Access Compliance Report Public Rights-of-Way (Pedestrian Signals)

Main Street: **NEWLAND_ST** Cross Street: **MADISON_AVE** Location: **NE**

ADA ID: **SGRK210929124540** Signal Type: **One Push Button-Non APS** Overall Compliance: **No** Severity Scores: **BTN 1: 35** **BTN 2: N/A** **No BTN: N/A**

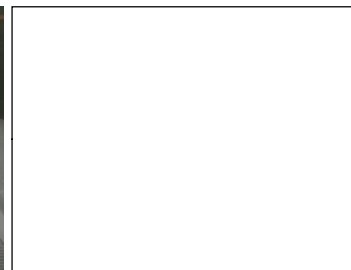
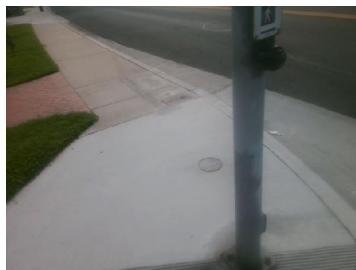
OC Std/PROW: **R404.2, R404.3, MUTCD 4e.08**

Possible Solutions: Replace Signal Push Button With APS Button. Remove and Replace Clear Space.
